**DEPARTMENT OF VETERANS AFFAIRS
Veterans Health Administration
National Health Physics Program
2200 Fort Roots Drive
North Little Rock, AR 72114**

Per NRC License 03-23853-01VA, we are enclosing closeout survey documentation for Jesse Brown VA Medical Center, Chicago, Illinois, for review and approval. The survey results are to release for unrestricted use the location of use at 333 East Huron Street, except for continued use of materials under 10 CFR 35.100 and 35.200.

This is an amendment request to release the VA Lakeside Building, located at 333 E. Huron, Chicago, IL, for unrestricted use, except for continued operation of our Nuclear Medicine Service.

**VA Lakeside Building
Radioactive Waste Room
Tritium Contamination and Dose Assessment**

VA Chicago Lakeside Campus - Final Status Survey
Lakeside Hospital Building - Survey Unit LS-6

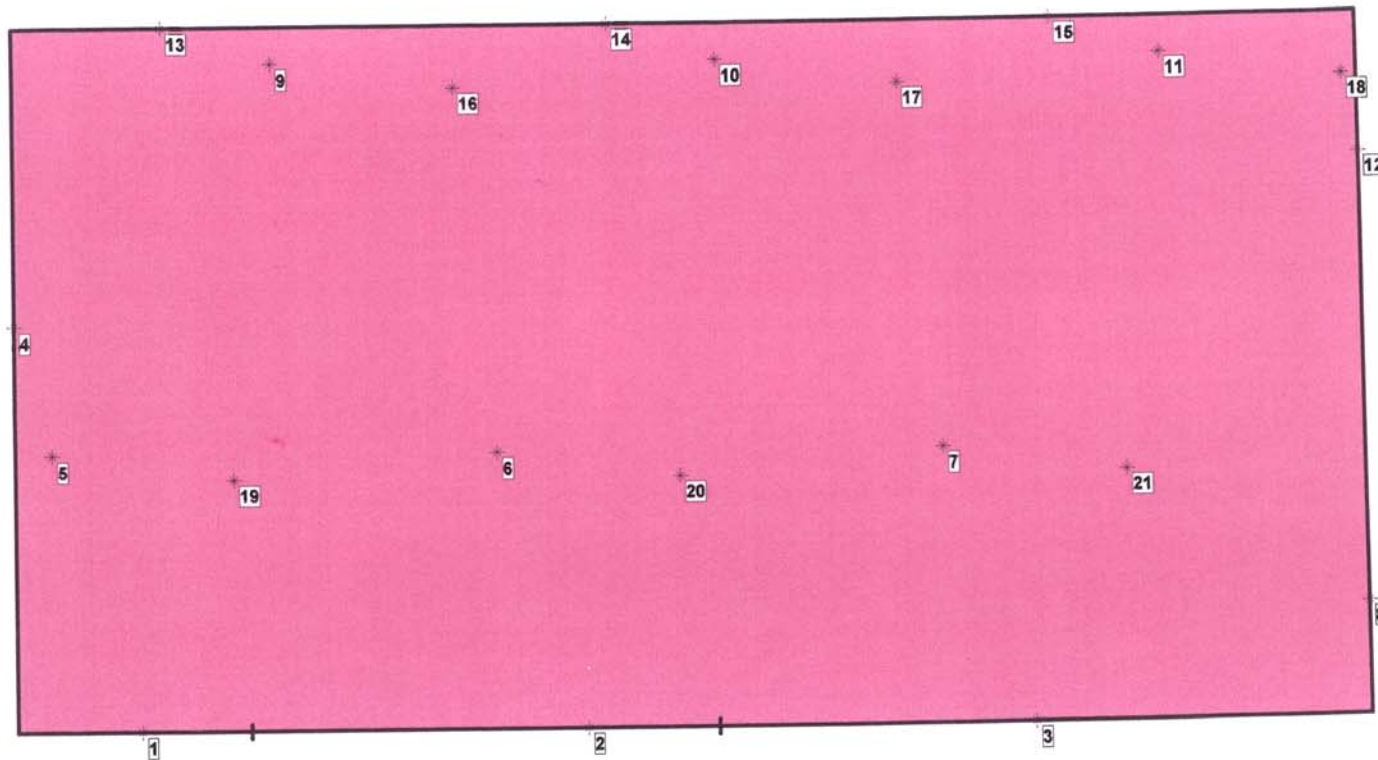
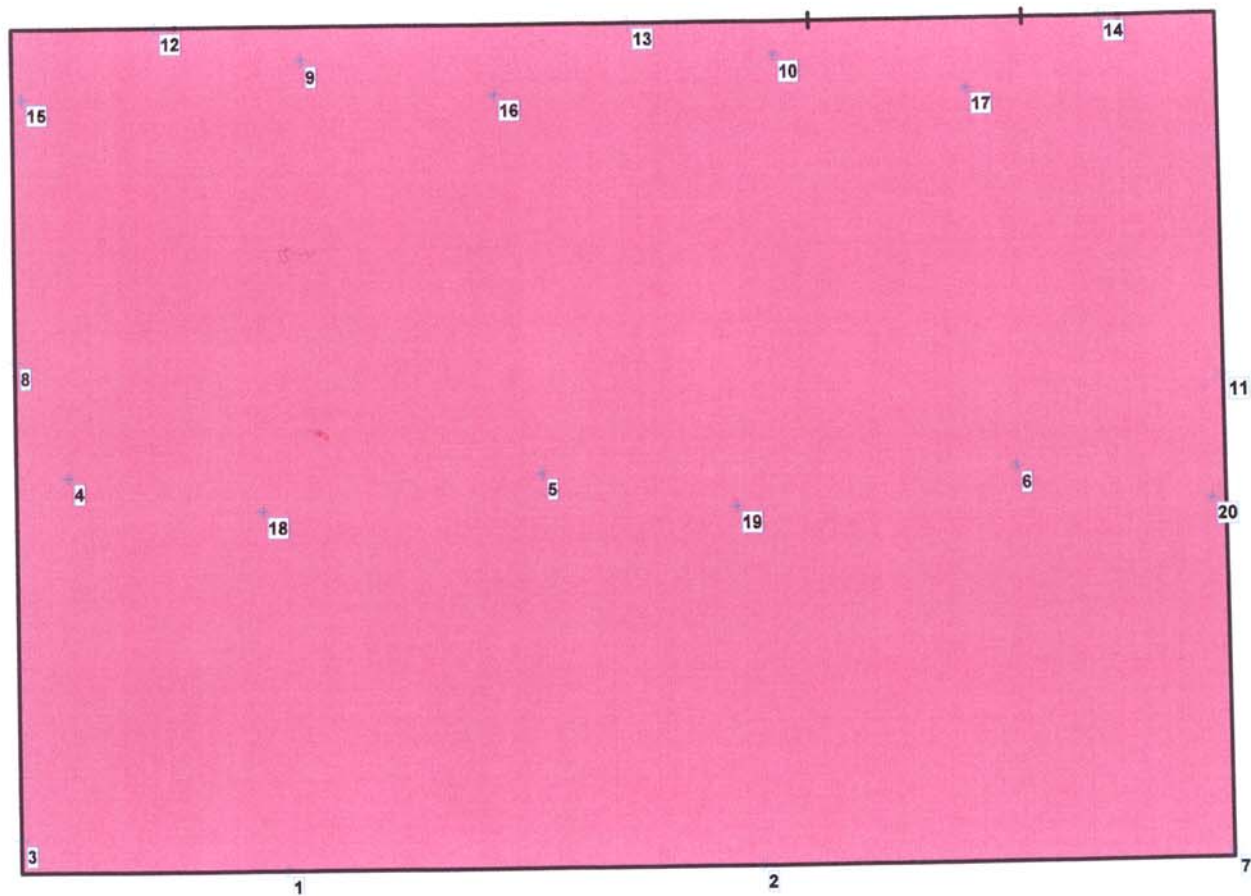
4. Q: In 3. above, this point is contained in the LS-2 SU. Referring to this section, the SU on the first sheet is not identified the same as in Table 2-1. Please clarify. Please also evaluate all of the other SUs as well to insure that the information and all locations stated in Table 2-1 is included, referenced and surveyed. For example, LS-03 states that Rooms 2SB-04 through -08 plus the corridor comprise the SU. However, no LSC data is provided for 2SB-04.

A: The point referred to in Comment #3 is in SU LS-6. The scope of the FSS in each SU includes all types of measurements outlined in the FSS Plan. Table 2-1 is a listing of the physical extents of each SU as shown on the maps in Appendix A. LS-03 included room 2SB-04 (2 static measurement locations and wall/floor scan measurements). Smears weren't taken in this room because the HSA indicates it was always used as an x-ray therapy room with no record of sealed or unsealed source usage. Several similar locations were not smeared for this same reason.
